HISTORIC AND DESIGN REVIEW COMMISSION

HDRC CASE NO:	**2018-367**
ADDRESS:	9599 BRAUN RD
LEGAL DESCRIPTION:	NCB 18230 BLK LOT 25 (BRAUNS FARM COMMERCIAL) & NCB 15664 BLK LOT P-2B
ZONING:	C-1,HE
CITY COUNCIL DIST.:	7
LANDMARK:	Grenwelge / Braun Farm Complex
APPLICANT:	Ginger Johnson
OWNER:	Immersion Outfitters Ministries
TYPE OF WORK:	Demolition of non-original additions, construction of a rear and side addition, exterior modifications
APPLICATION RECEIVED:	August 20, 2018
60-DAY REVIEW:	October 19, 2018

The applicant is requesting a Certificate of Appropriateness for approval to:

1 RAMP PLAN
3/8" = 1'-0"

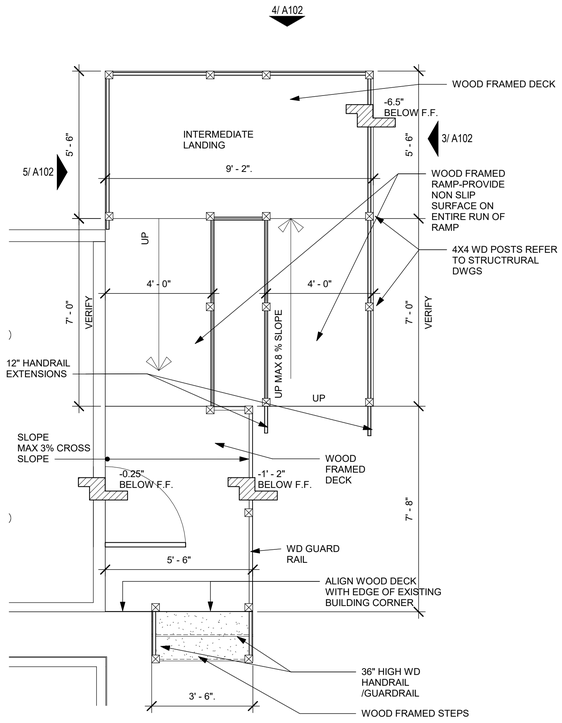
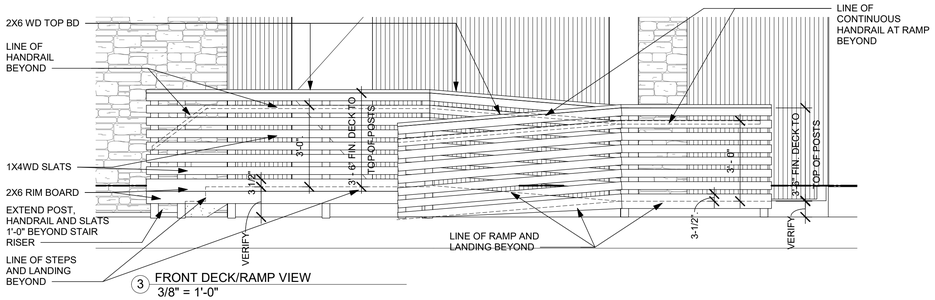
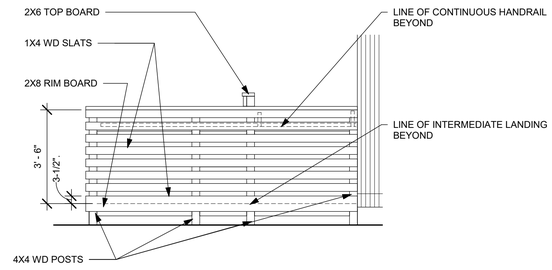
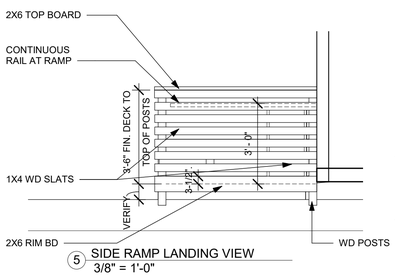
i. ADA RAMP – The applicant has proposed to construct a new wooden ADA ramp. The ramp will be located on the proposed rear addition and set back from the front façade of the primary limestone structure by approximately 16'-7". The ramp will be constructed of simple wood posts and balusters and feature one switchback. Staff finds the proposal conceptually appropriate.

Item 5, Staff recommends approval of the new ADA ramp based on finding e.

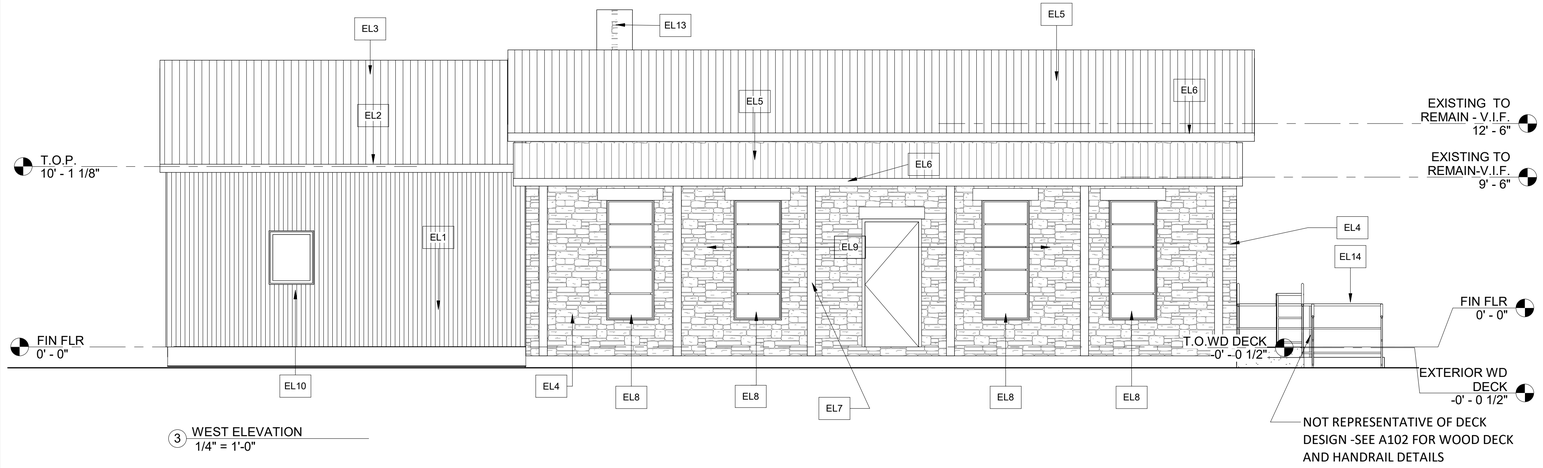
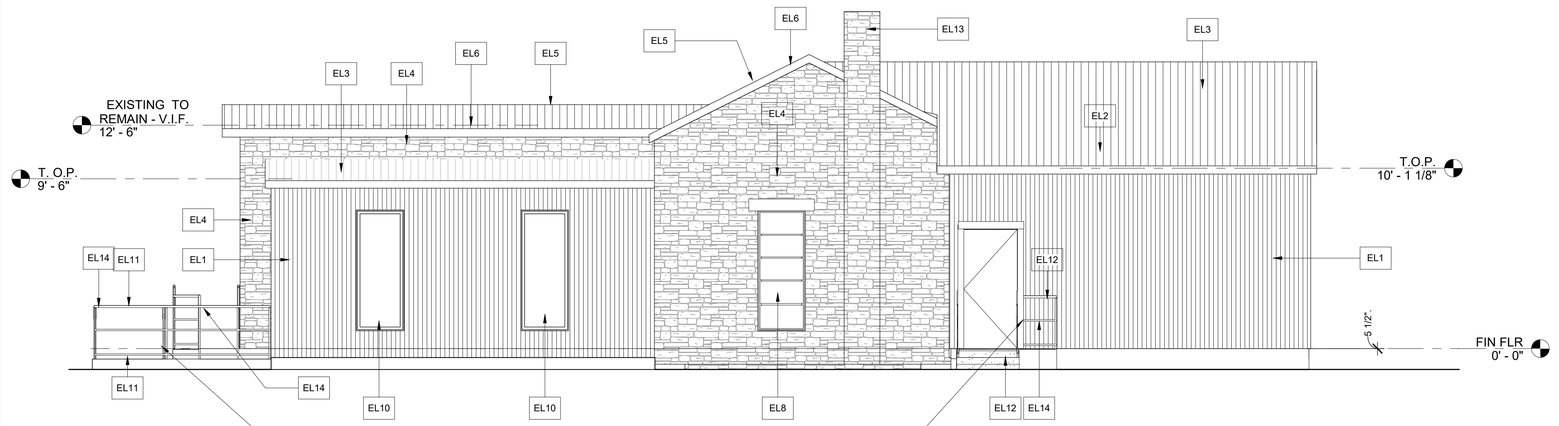
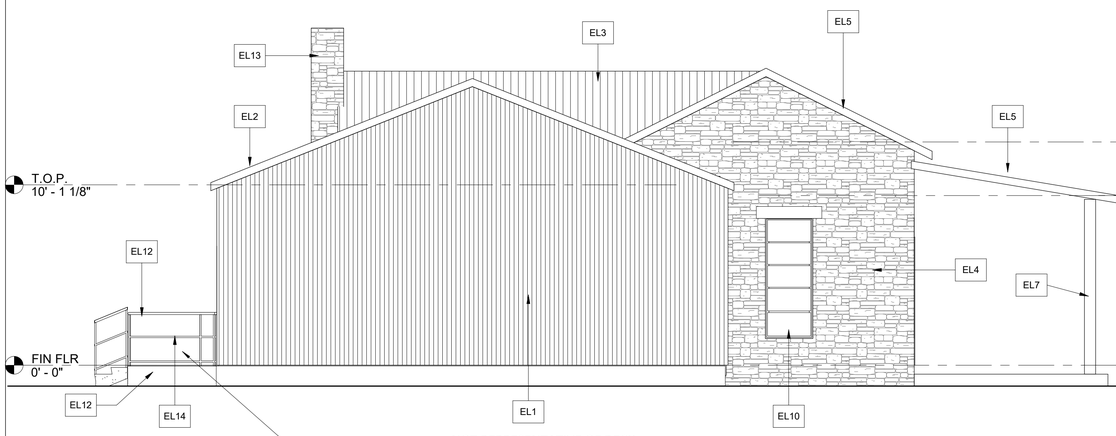
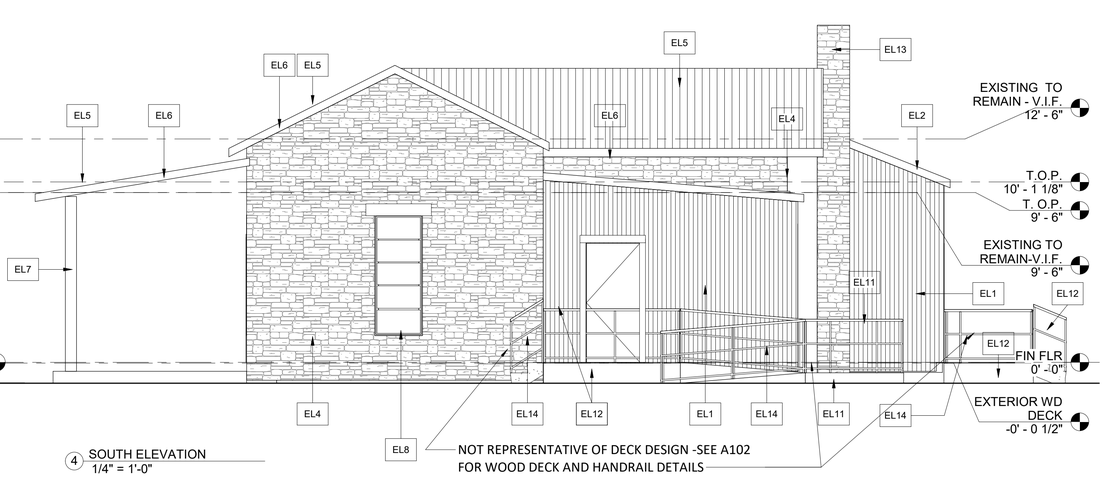
d. NEW ADDITIONS: MASSING AND FOOTPRINT – The applicant has proposed to construct two additions in the same general location of the previous non-contributing additions. The side addition will total approximately 560 square feet, which is slightly larger than the previous side addition, and will be set back from the front façade of the limestone structure by approximately 10 feet. The rear addition will occupy the same space as the previous non-original rear enclosed porch and will utilize the concrete pad. The side addition will feature a slightly lower height than the primary limestone structure and the rear addition will tie into the existing standing seam metal roof. While staff finds the general massing and location of the rear addition to be appropriate, staff finds that the side addition obscures a significant amount of the side elevation of the historic limestone structure. According to the Historic Design Guidelines, additions should be located to the rear whenever possible. There is ample space behind the structure to construct an addition. Staff finds that the proposed side addition should be relocated to the rear of the historic building to be more consistent with the Historic Design Guidelines.

e. NEW ADDITIONS: ROOF – The new side addition will feature a side gable roof with a pitch that matches the side gable of the limestone structure. The rear addition will feature a simple shed roof, similar to the previous non-original porch. The roofing will be standing seam metal to tie into the existing limestone structure's roof. Staff finds the general design approach for the roof configurations, as well as the material, to be appropriate, but finds that the side addition should be relocated to the rear as noted in finding c.

f. NEW ADDITIONS: WINDOWS AND DOORS – The applicant has proposed to install several window and door openings on the new additions. Several windows and doors will match the opening sizes and proportions of those on the existing limestone structure, which are consistent with the Guidelines. However, the proposed elevations indicate that the windows will not be divided and will contain a single pane of glass, which is inconsistent with the Guidelines. Additionally, one window on the front elevation of the side addition will feature a square proportion. Staff finds this square proportion to be inconsistent. The north elevation of the side addition also does not feature any window openings. As noted in findings c and d, the side addition should be relocated. The applicant should install openings on every elevation that feature profiles and configurations that are consistent with the Guidelines.

g. NEW ADDITIONS: FAÇADE MATERIAL – The applicant has proposed to install new vertical cedar siding on the additions. The siding features a profile of a few inches and will not feature battens. According to the Historic Design Guidelines, materials that match in type, color, and texture and include an offset or reveal to distinguish the addition from the historic structure should be used whenever possible. Any new materials introduced to the site as a result of an addition must be compatible with the architectural style and materials of the original structure. Staff does not find vertical cedar siding appropriate without the use of battens.

Items 2 and 3, Staff does not recommend approval of the proposed side and rear additions at this time based on findings c through g. Staff recommends that the applicant make the following modifications prior to resubmitting to the HDRC:

i. That the applicant relocates the proposed side addition to the rear of the historic structure as noted in finding c.
ii. That the additions feature true board and batten siding with boards that are twelve (12) inches wide with battens that are 1 – ½" wide.
iii. That the applicant installs fenestration featuring appropriate proportions and configurations on all elevations of the additions as noted in finding e.
iv. That the windows feature a one over one configuration and meet the following stipulations: Meeting rails must be no taller than 1.25" and stiles no wider than 2.25". There should be a minimum of two inches in depth between the front face of the window trim and the front face of the top window sash. This must be accomplished by recessing the window sufficiently within the opening or with the installation of additional window trim to add thickness. Window trim must feature traditional dimensions and architecturally appropriate sill detail. Window track components must be painted to match the window trim or concealed by a wood window screen set within the opening.

v. That the standing seam metal roof features panels that are 18 to 21 inches wide, seams that are 1 to 2 inches tall, a crimped ridge seam and a standard galvalume finish.
